# CITY OF ALBUQUERQUE

**Re: Lot 23, Block 11, Unit 18 SAD 228  
6508 Petirrojo Rd. NW  
Grading and Drainage  
Engineers Stamp Date 7/21/2021 (C10D003H23)  
Certification dated: 11-18-2021**

## DRAINAGE AND TRANSPORTATION INFORMATION SHEET (REV 6/2018)

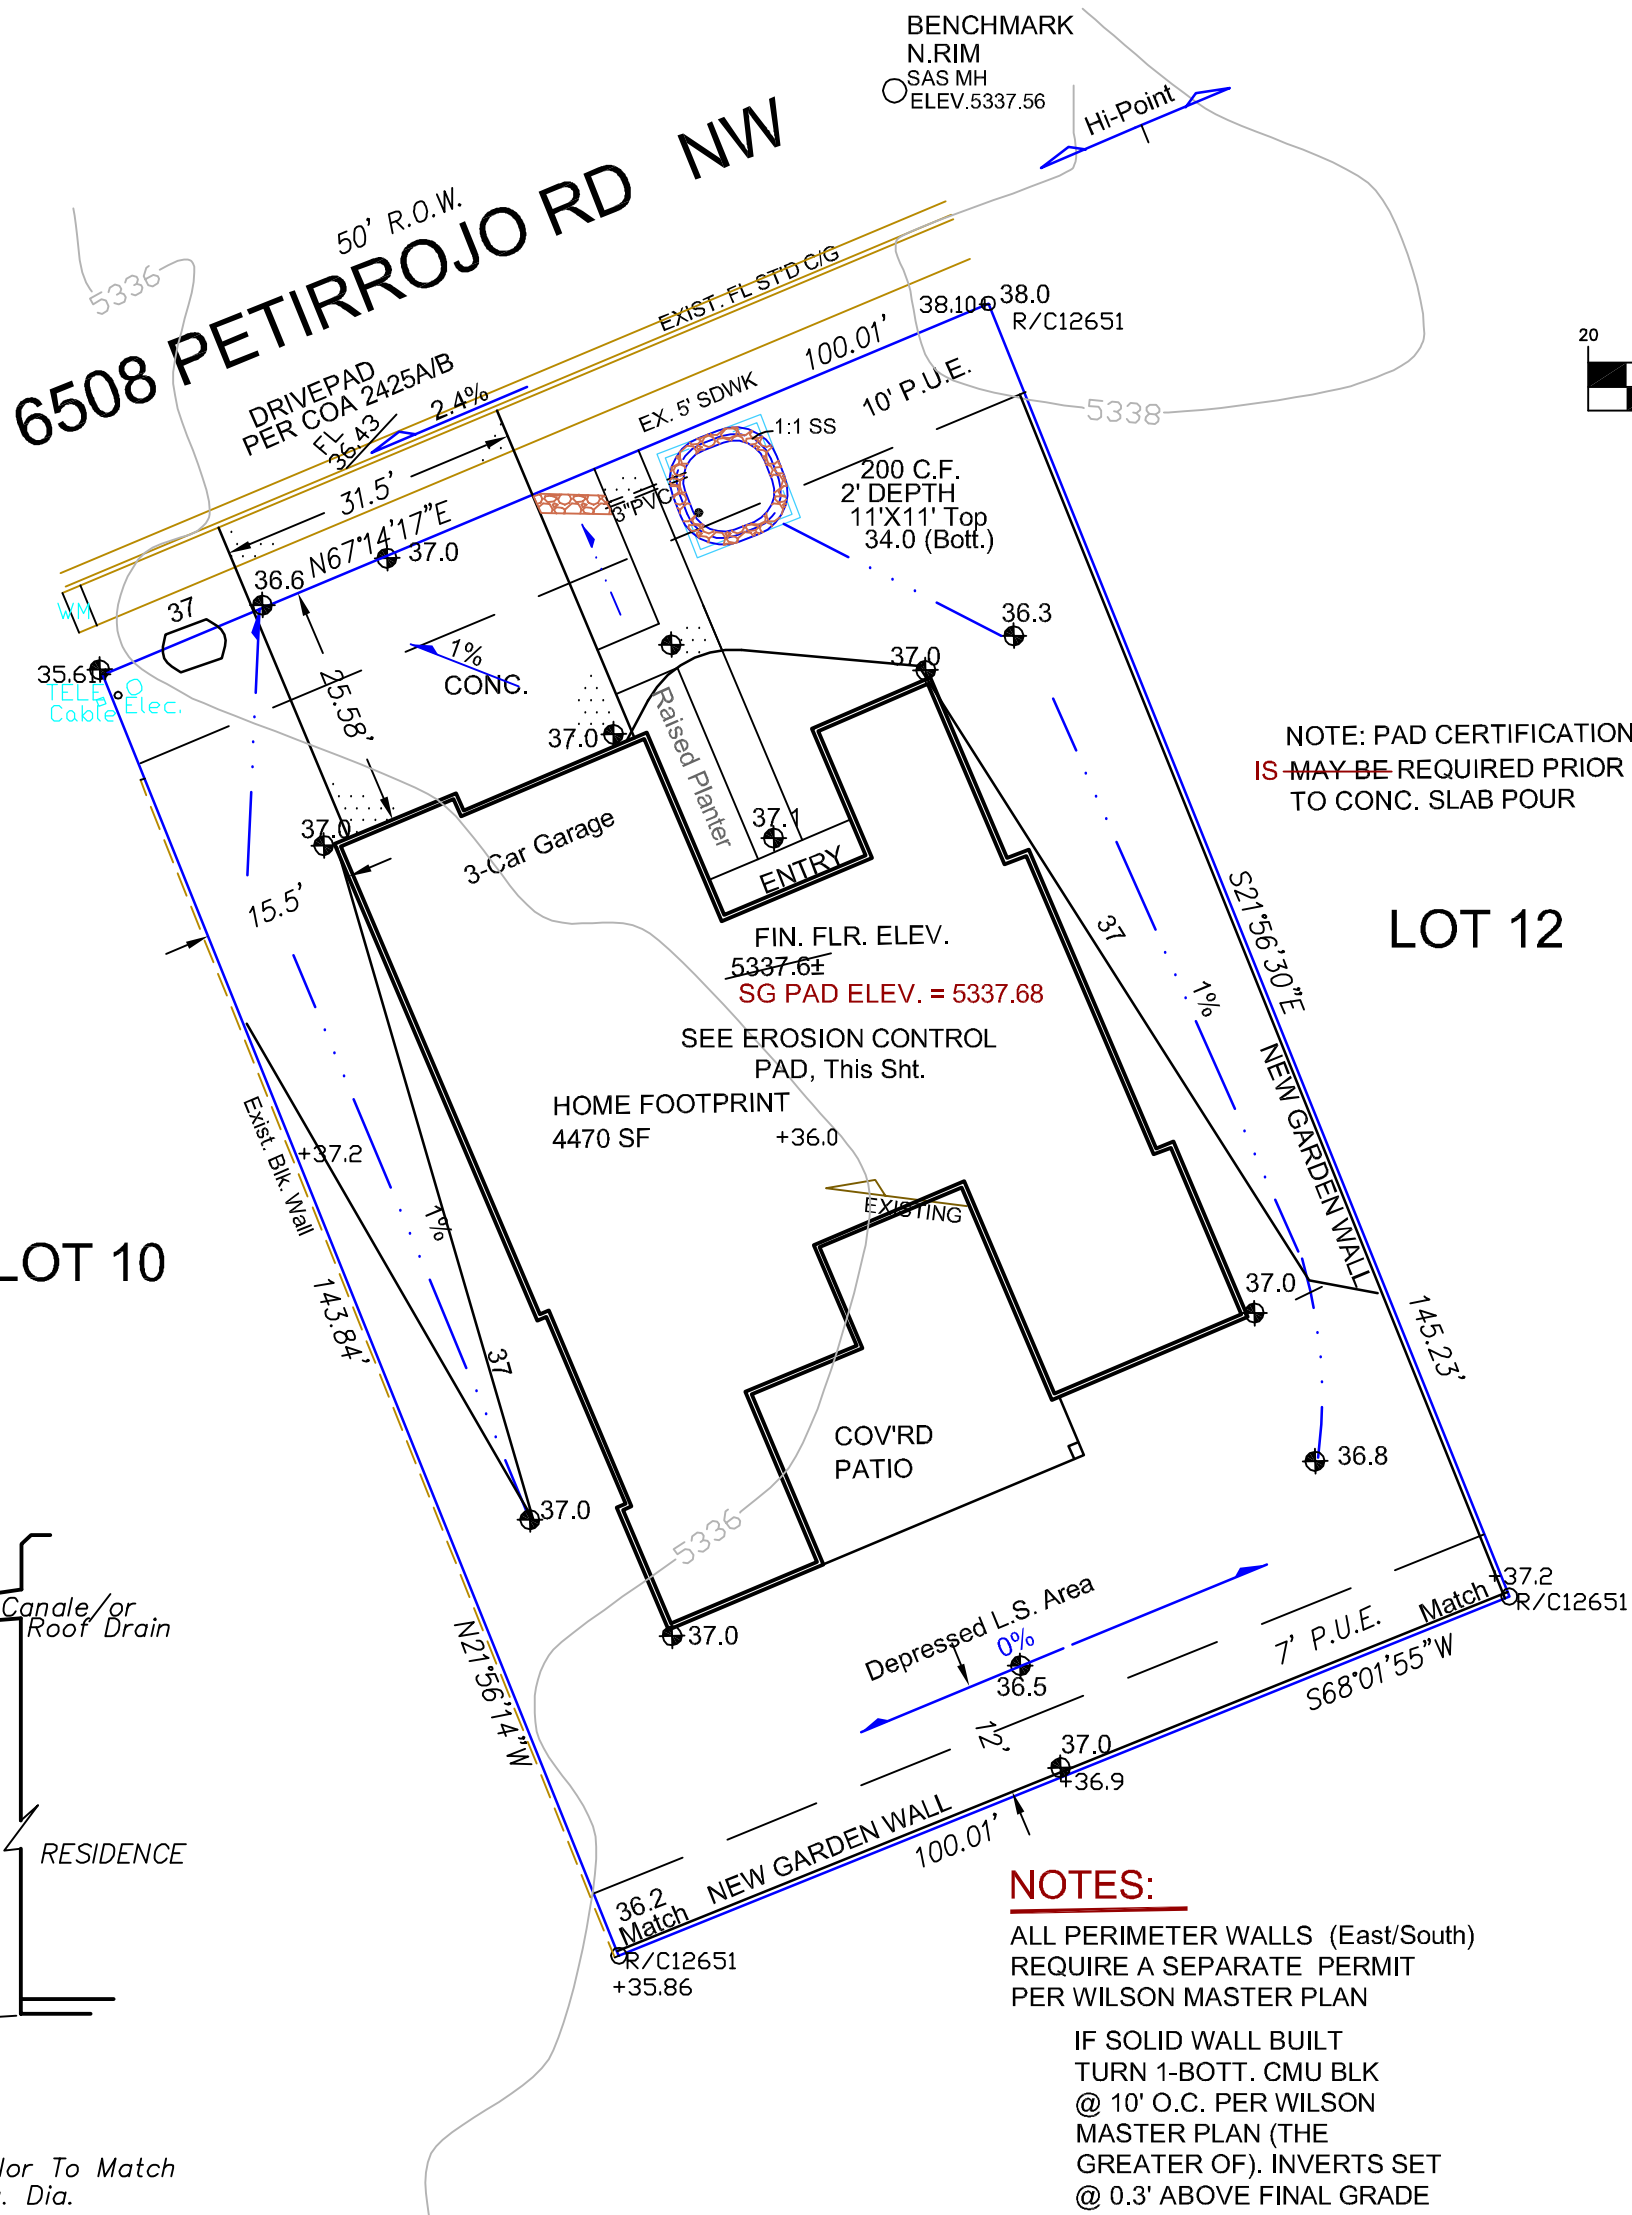
**Reiterate to the Owner/Contractor that a separate permit for a garden/retaining wall must be obtained, with the approved G&D plan and Pad Certification. Also, let the owner/contractor know that if a pool is to be added in the future the G&D plan will need to be modified showing the location of the pool and the land treatment differences. Also advise the owner & Contractor that dirt is not allowed in the public right of way to climb the curb. Crusher fines or lumber is allowed. If dirt is used this will delay going forward with the construction of the home.**

Prior to Certificate of Occupancy release, Engineer Certification per the DPM checklist of this plan will be required.
